**TOWN OF NEWBURGH
PLANNING BOARD
TECHNICAL REVIEW COMMENTS**

PROJECT: DARRIGO SOLAR FARM
PROJECT NO.: 19-24
PROJECT LOCATION: SECTION 86, BLOCK 1, LOT 96
REVIEW DATE: 26 FEBRUARY 2021
MEETING DATE: 4 MARCH 2021
PROJECT REPRESENTATIVE: ARDEN CONSULTING- MICHAEL MORGANTE, P.E.

Response to Comments

EXHIBIT D
Landscape Plan L-110

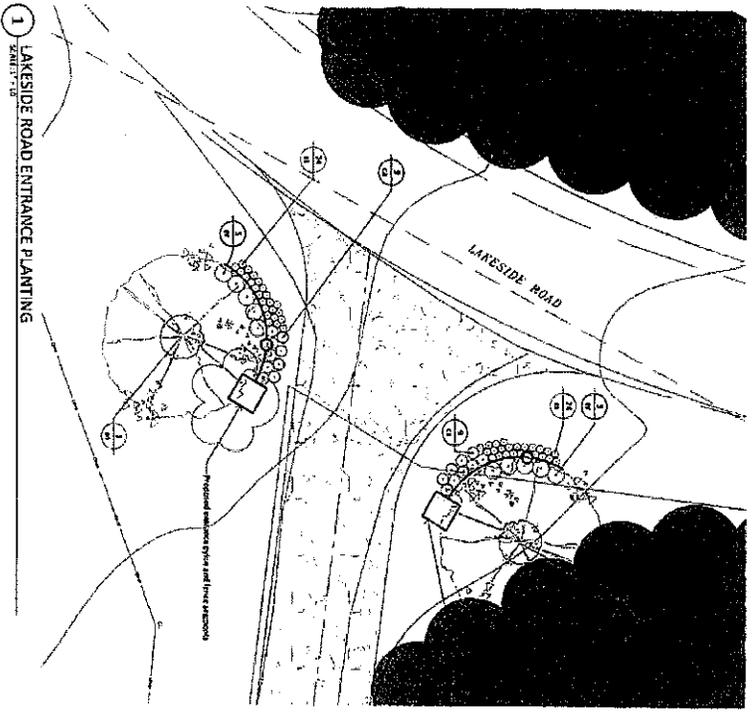
9. Tree clearing is identified on the north side of the Meadow Hill access road behind two residential properties. The purpose of this additional tree clearing should be addressed.
Subsequently corrected as per Landscaping Plan L-110 of 11/05/2020 and as exhibit D.

15. The landscape plan should address the number of plants proposed to be located on the site.
Subsequently corrected as per Landscaping Plan L-110 of 11/05/2020 and as exhibit D.

This note has been added to the Landscape Plan, see Sheet L110

EXHIBIT E
Landscape Plan L-111

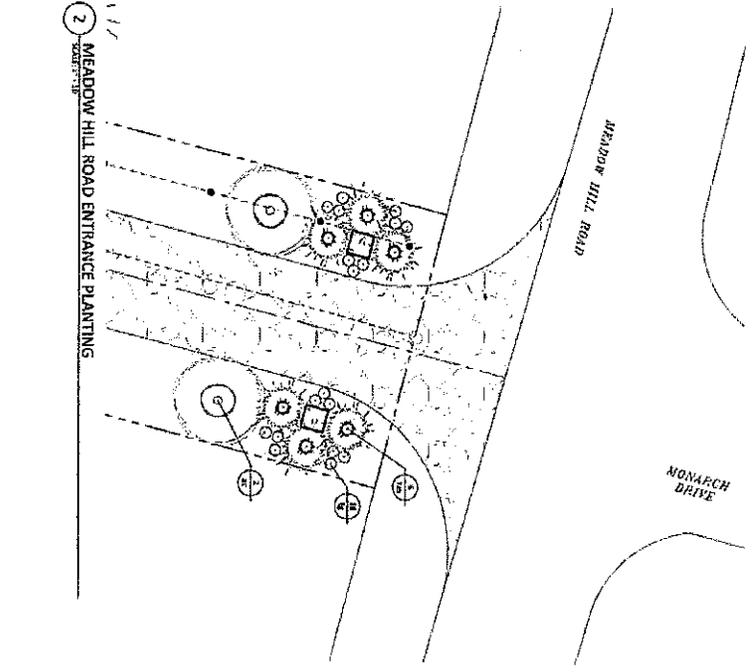
10. The project sponsor has submitted gate details which are inconsistent with the details depicted on the engineering plans.
Subsequently corrected as per landscaping Plan L-111 of 11/16/2020 and as exhibit E.

H. Viewshed Studies

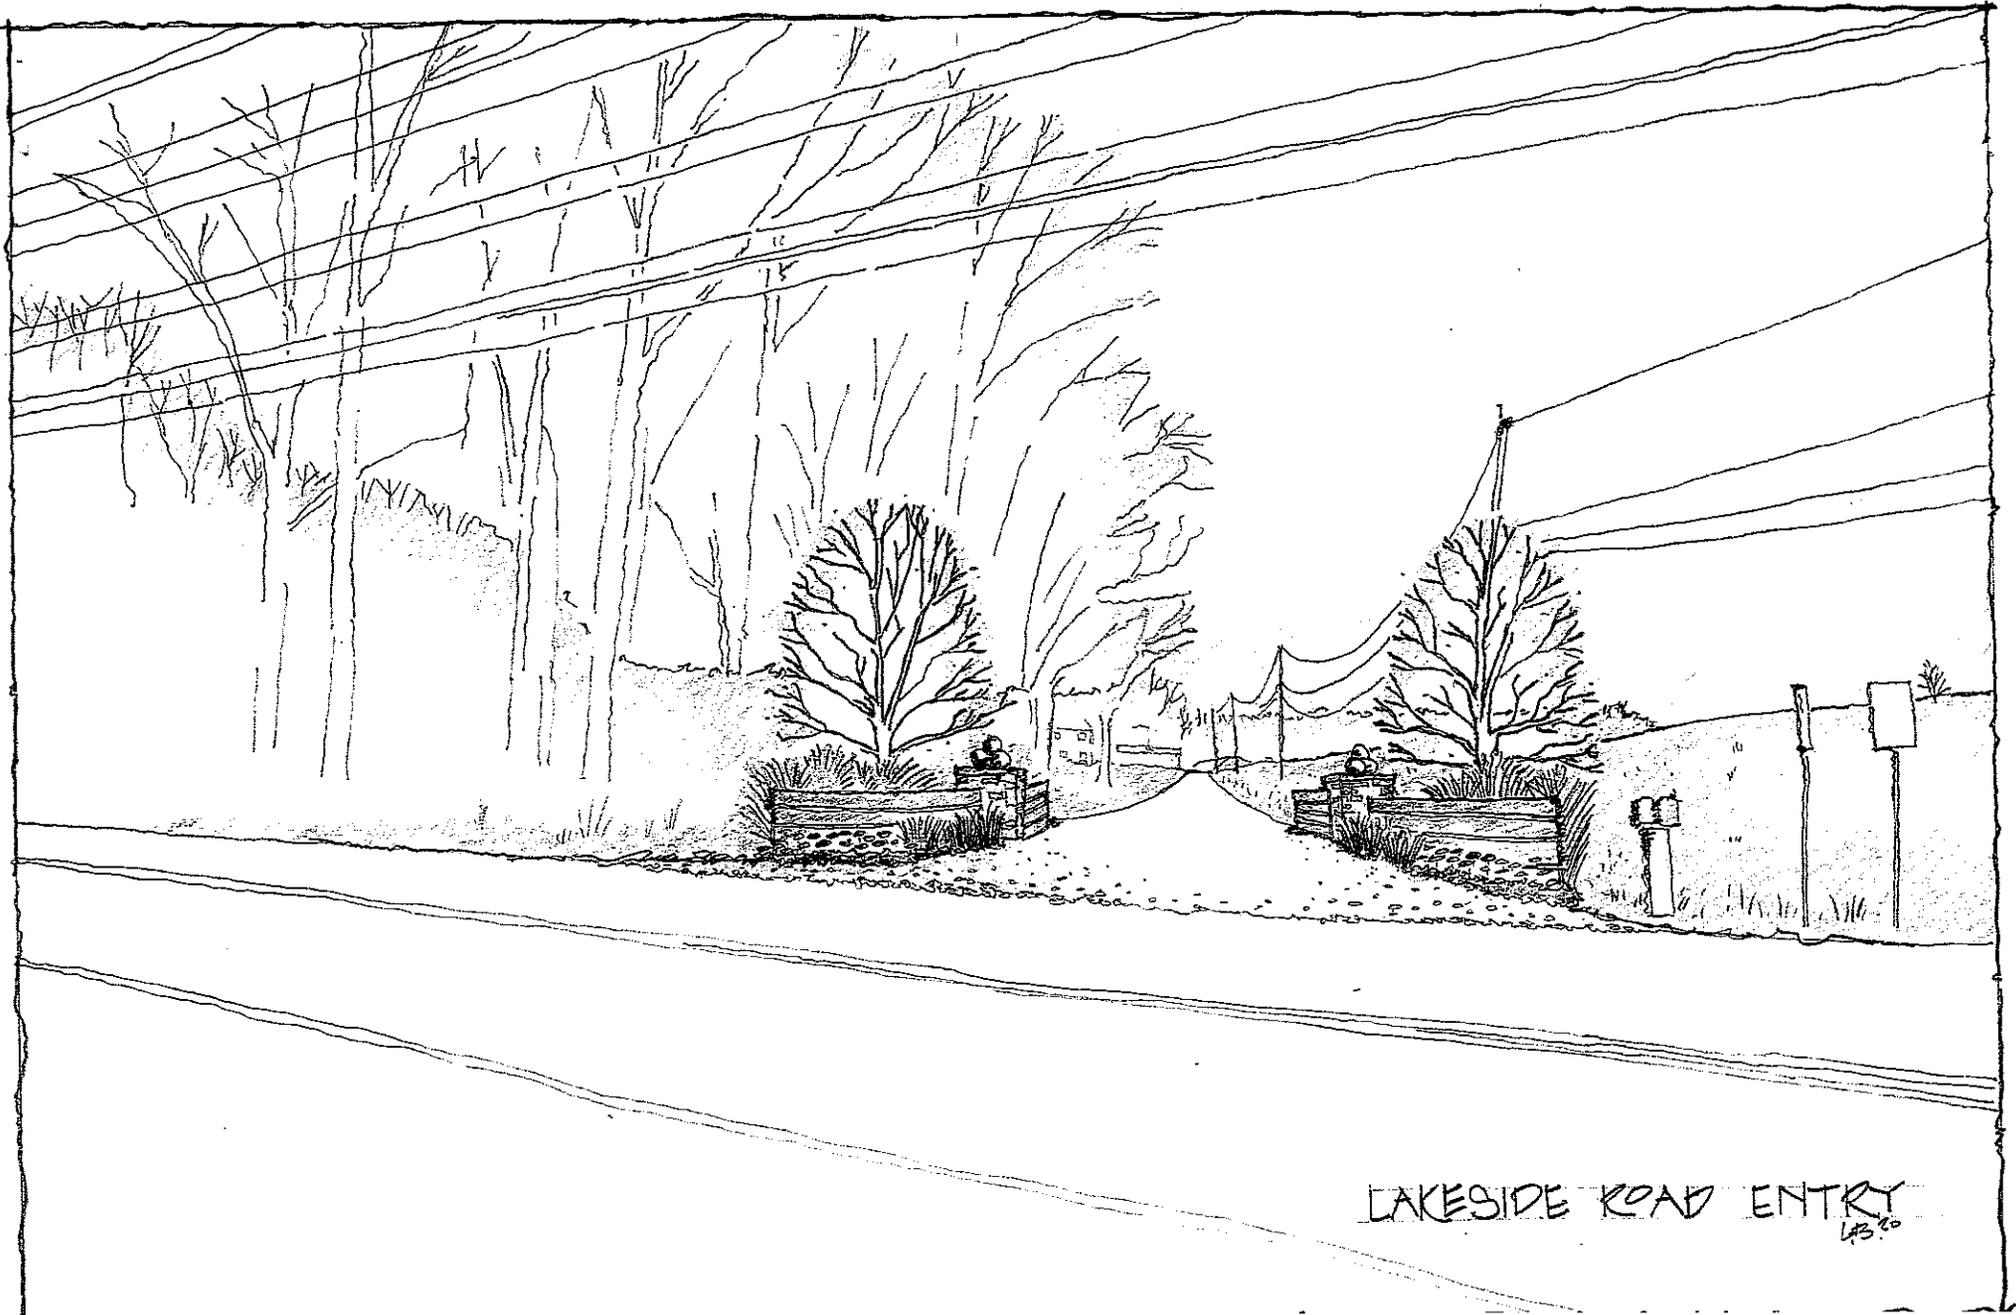
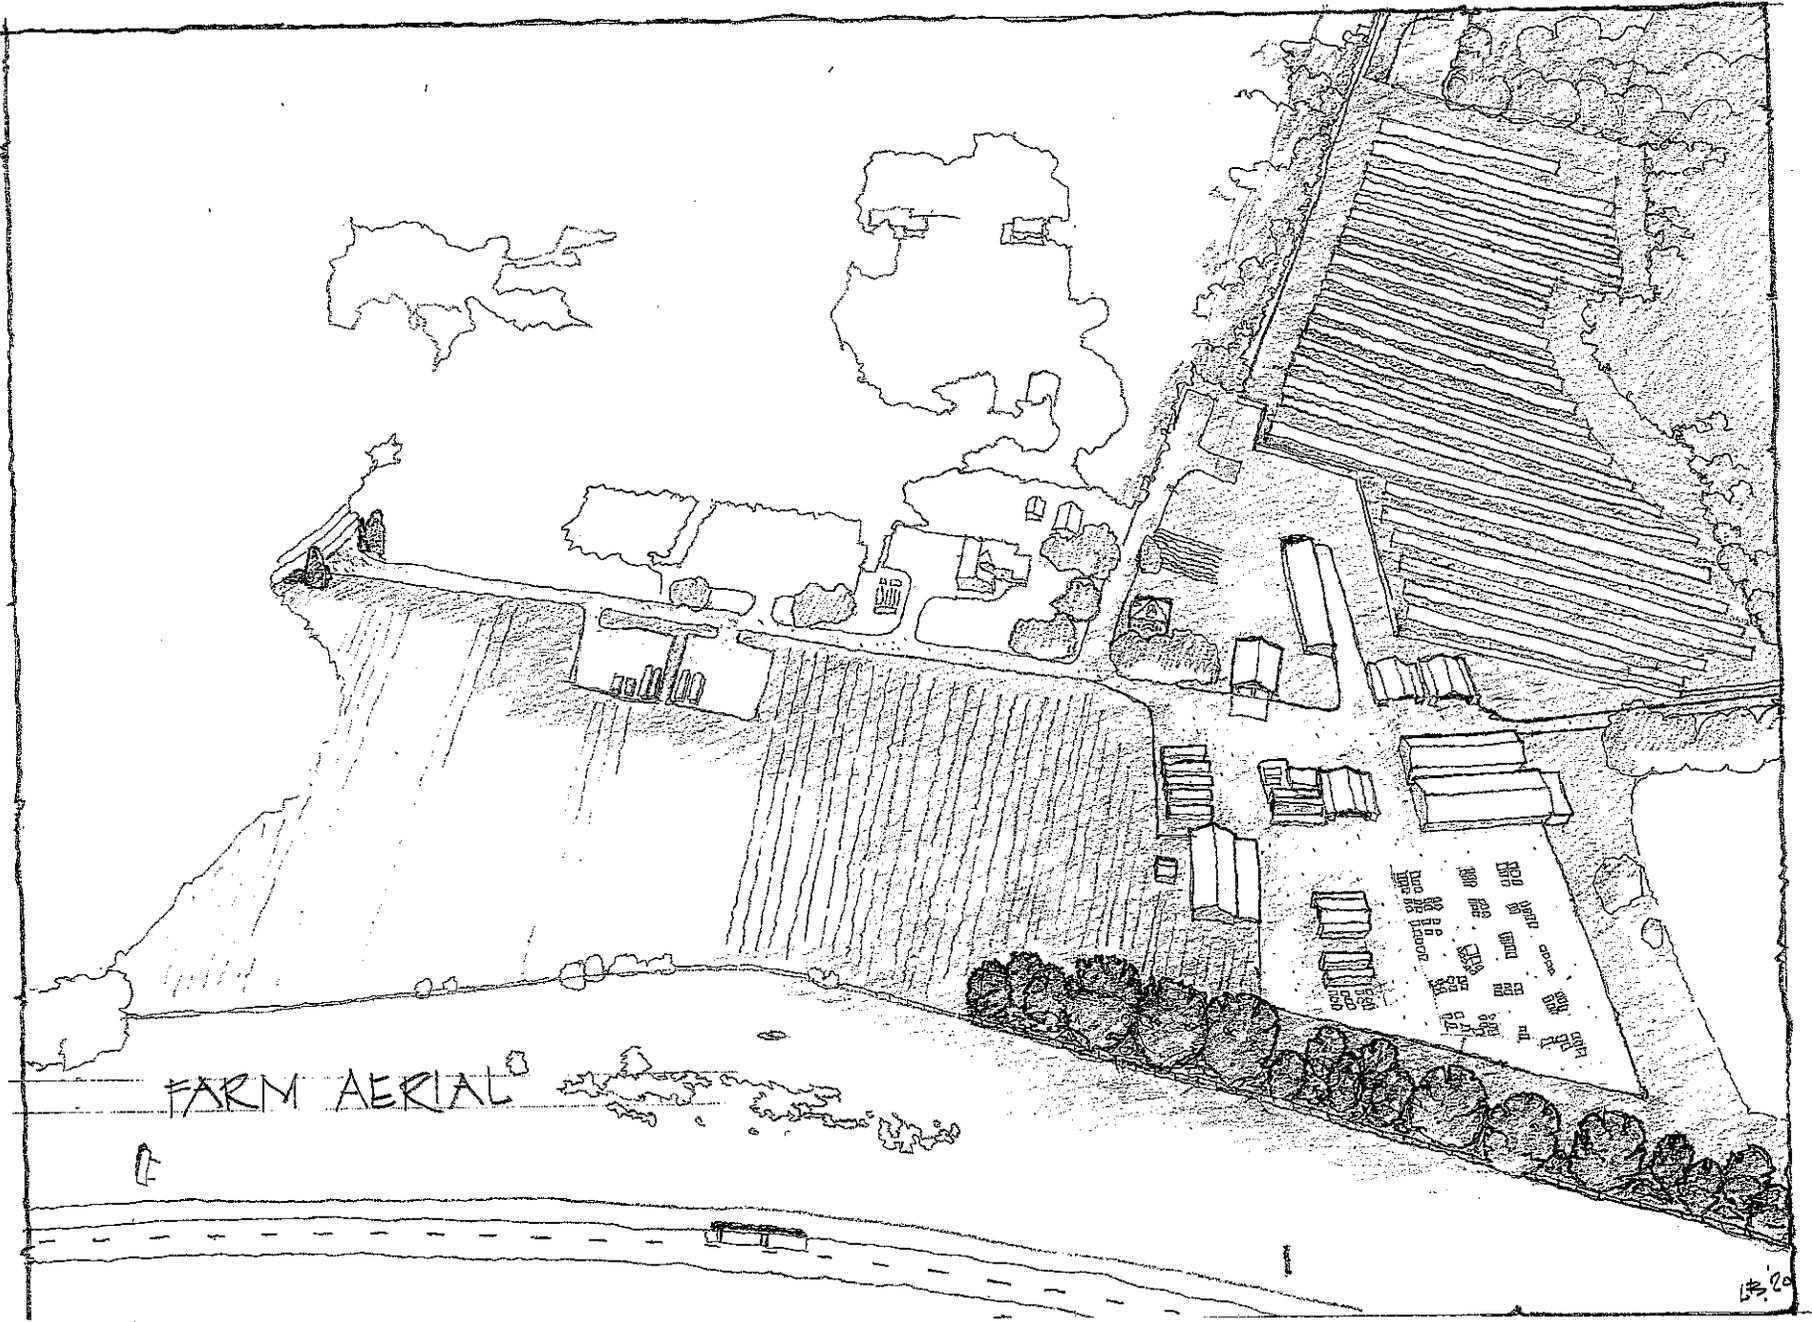
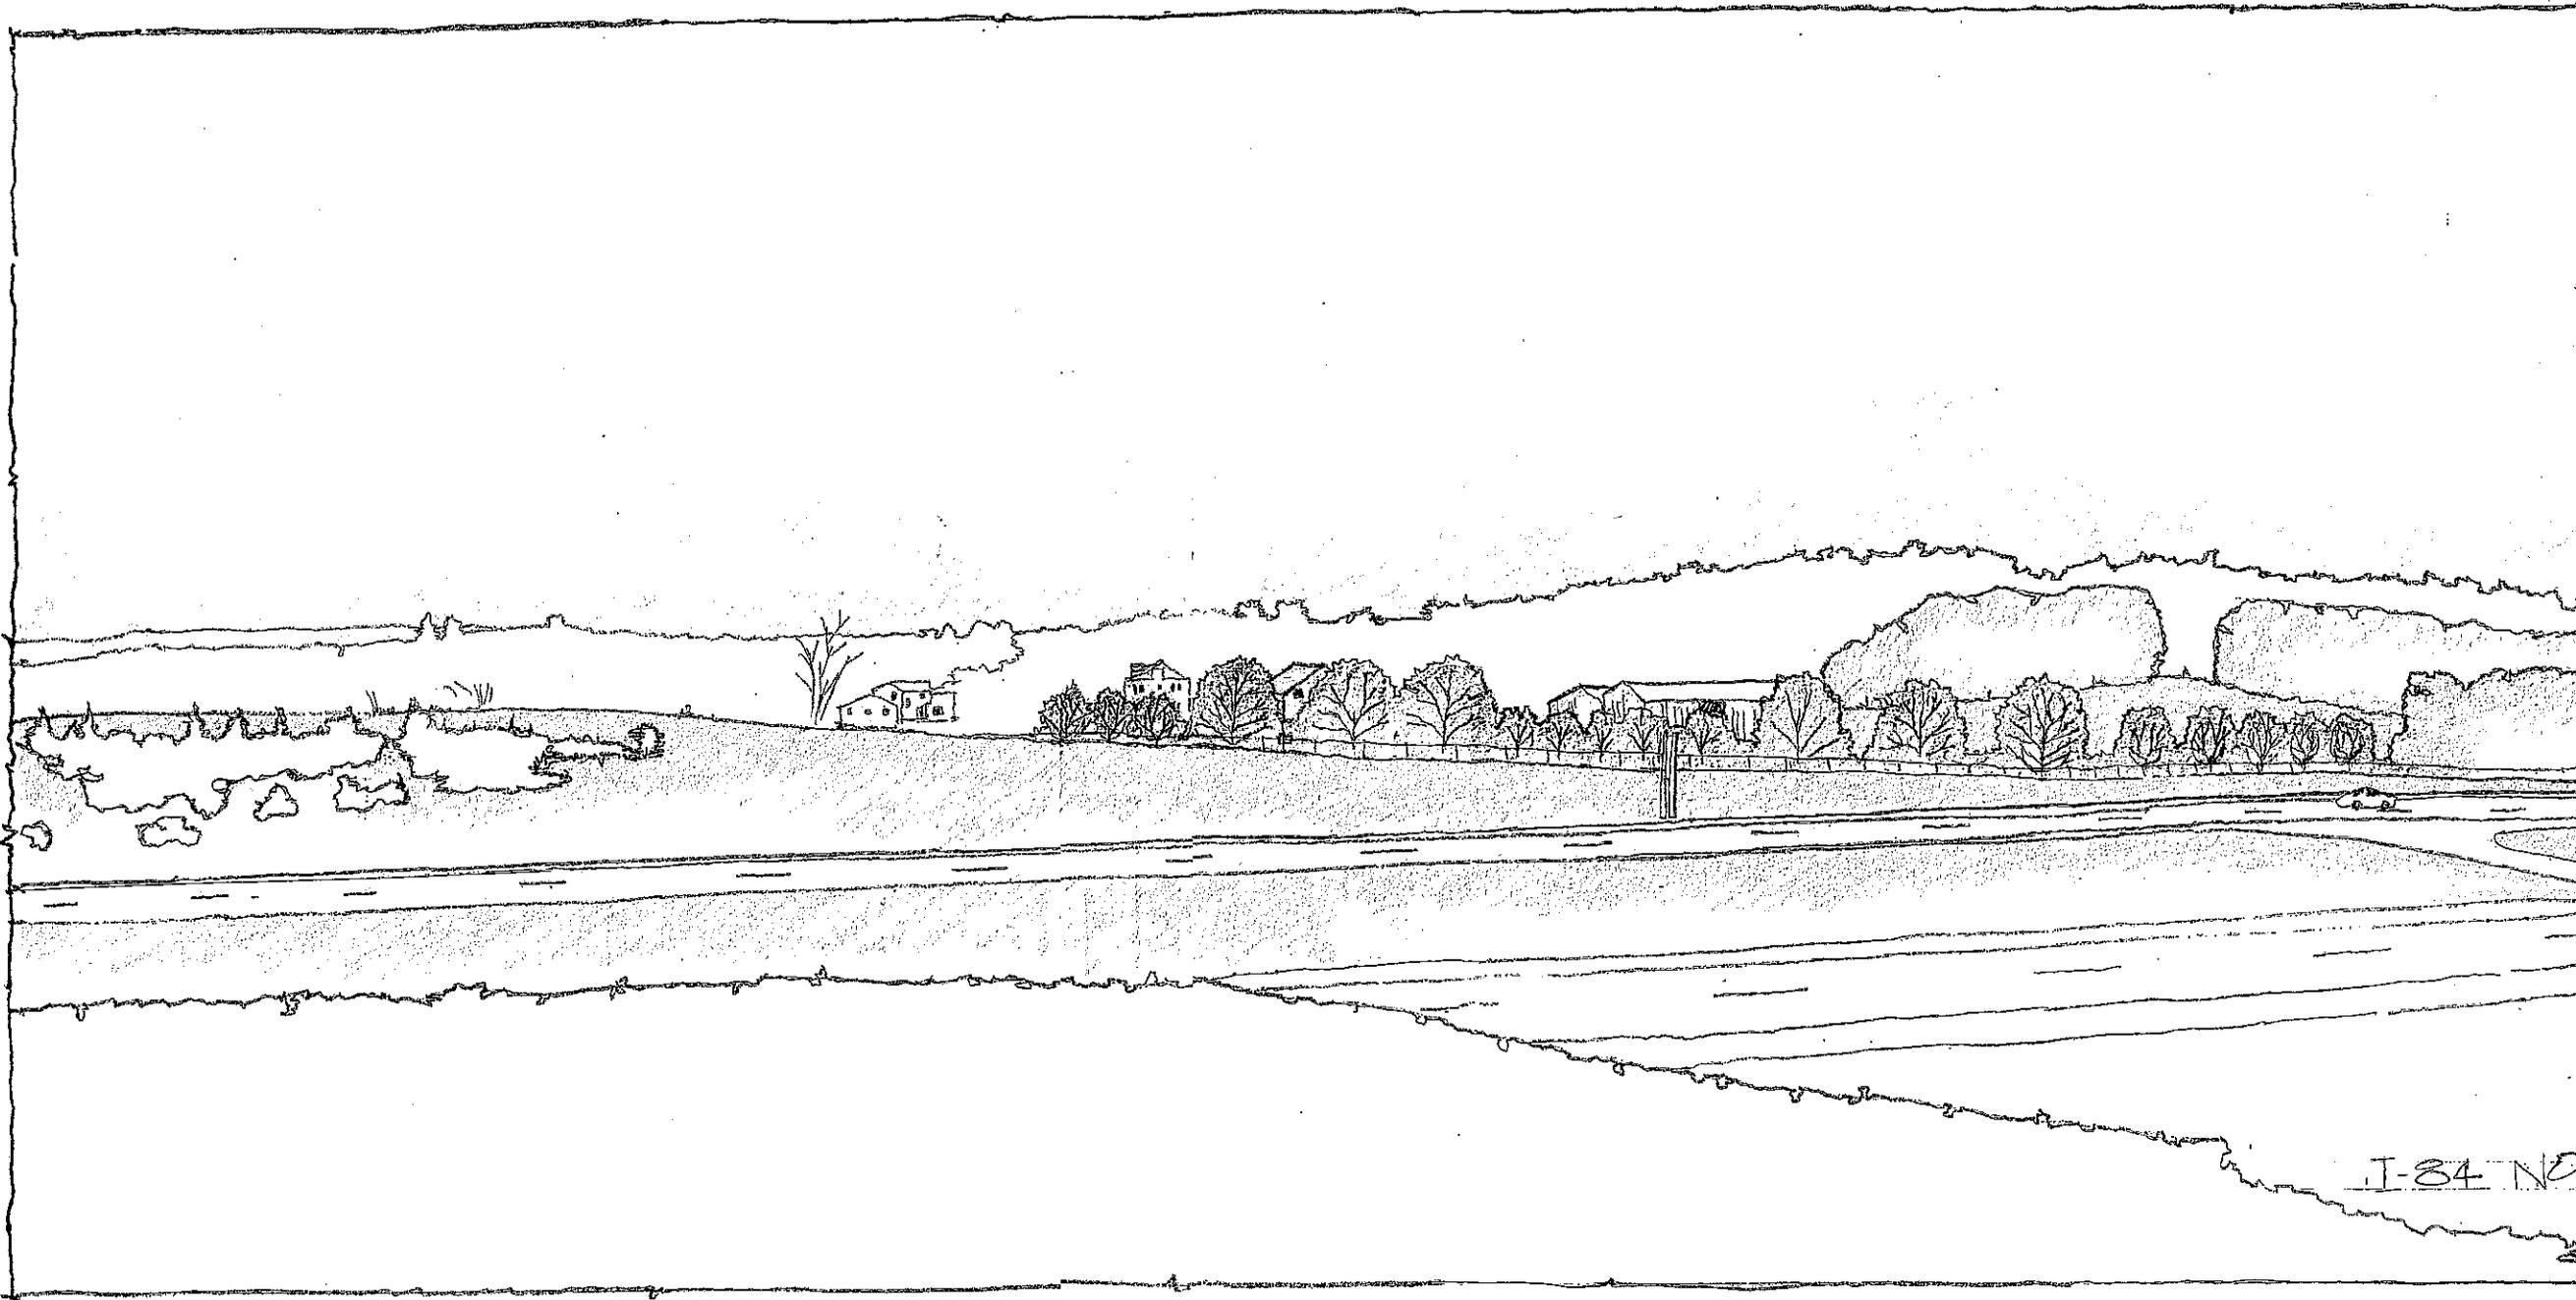
12. The Planning Board previously requested some visual simulations of the project from Amber Fields neighborhood / Monarch Drive / Meadow Hill Road / Patton Road and Lakeside Road. These visual assessments should be provided.
Drawings attached as exhibit H.

8. Viewshed studies of the 84 buffer, Lakeside, Meadow, Patton and Amber Fields view renderings.
See attached as Exhibit H.
9. Clean up proposal in writing for the Farm and Supply Yard.
See Attached as Exhibit J.
10. Landscape maintenance plan for the next three years for watering, feeding and care to insure its survival.
See attached as Exhibit K.
